PUC DOCKET NO. 47452

APPLICATION OF MUSTANG §
SPECIAL UTILITY DISTRICT TO §
AMEND WATER AND SEWER §
CERTIFICATES OF CONVENIENCE §
AND NECESSITY IN DENTON AND §
COLLIN COUNTIES §

**MUSTANG SUD’S RESPONSE TO COMMISSION STAFF’S
RECOMMENDATION ON ADMINISTRATIVE COMPLETENESS**

Application Exhibit
"Attachment 3.A."

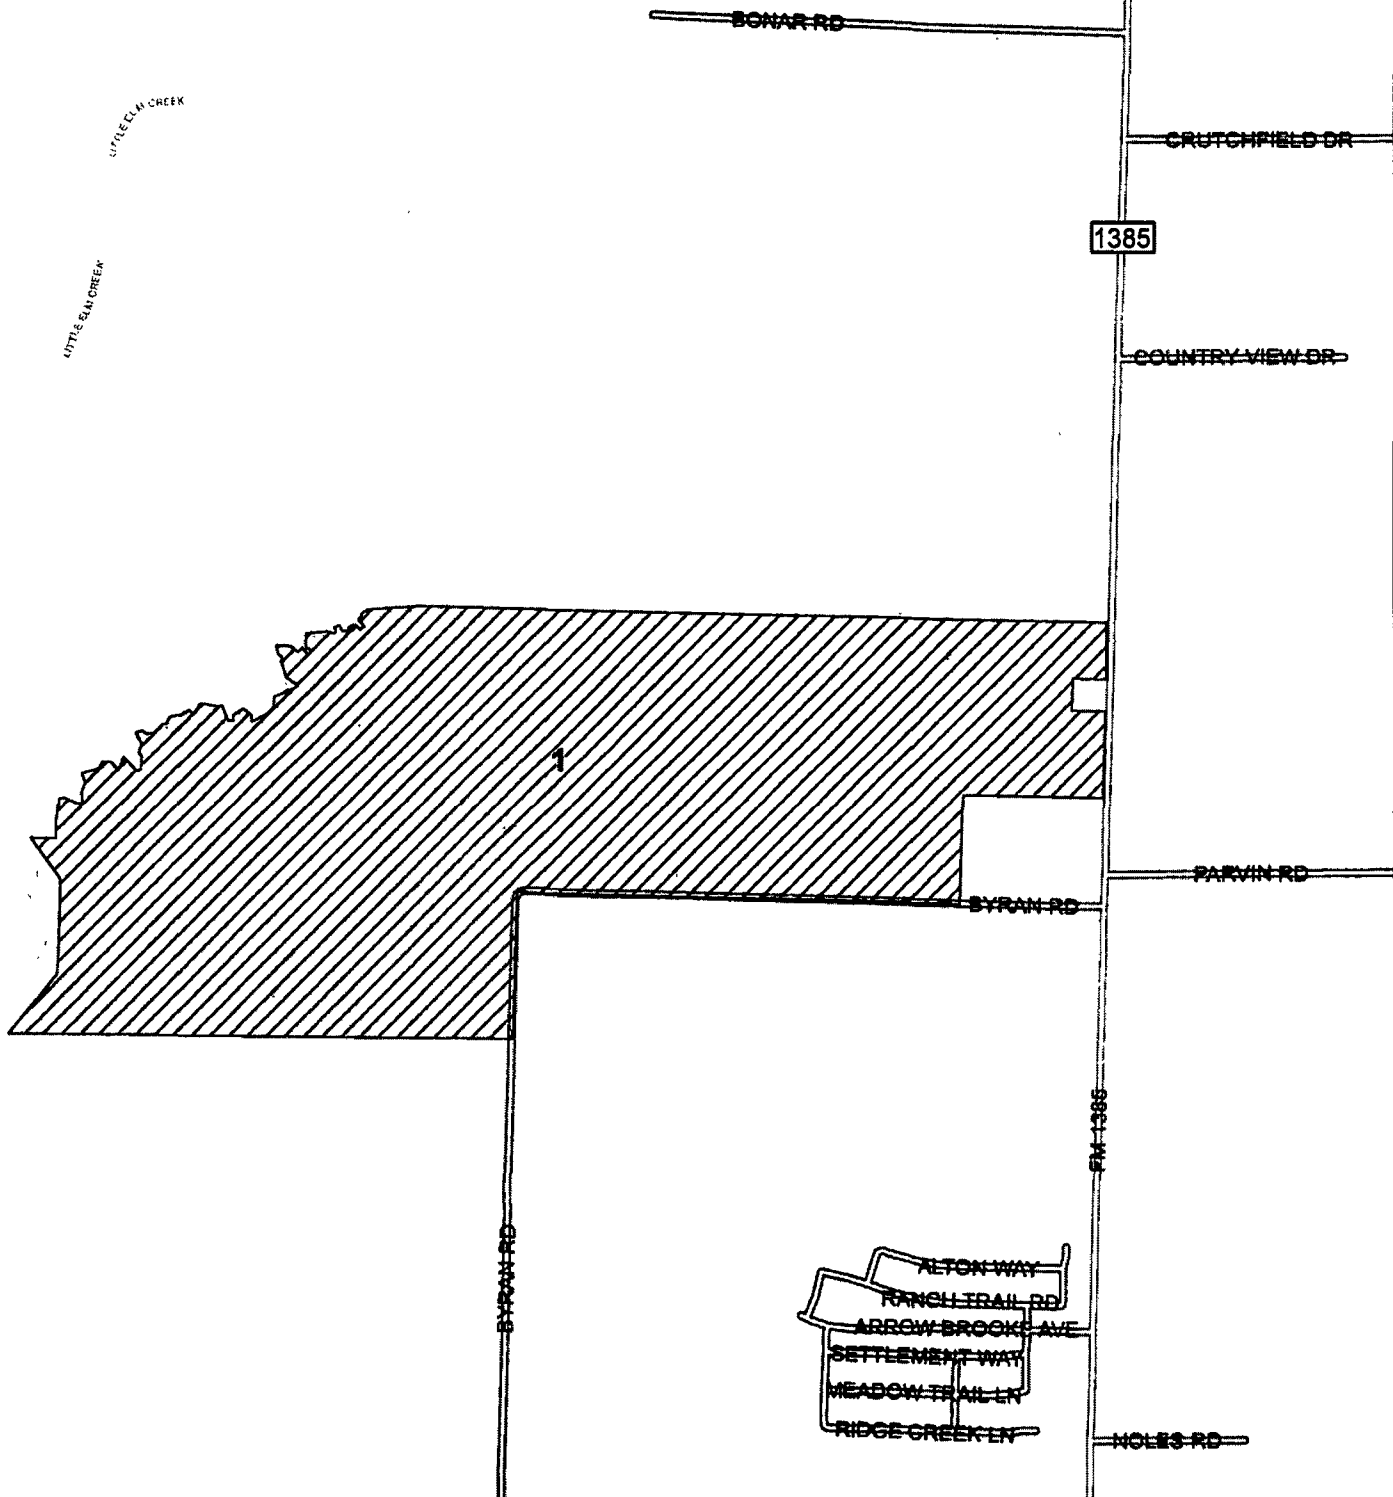
Mapping Content: Attachment A to this response contains replacement maps for Attachment 3.A., Attachment 3.B. (1 of 1), Attachment 3.B. (1 of 2) and Attachment 3.B. (2 of 2). The tract numbers have been added to these maps as requested by the PUC Staff. The tract acreage is as follows:
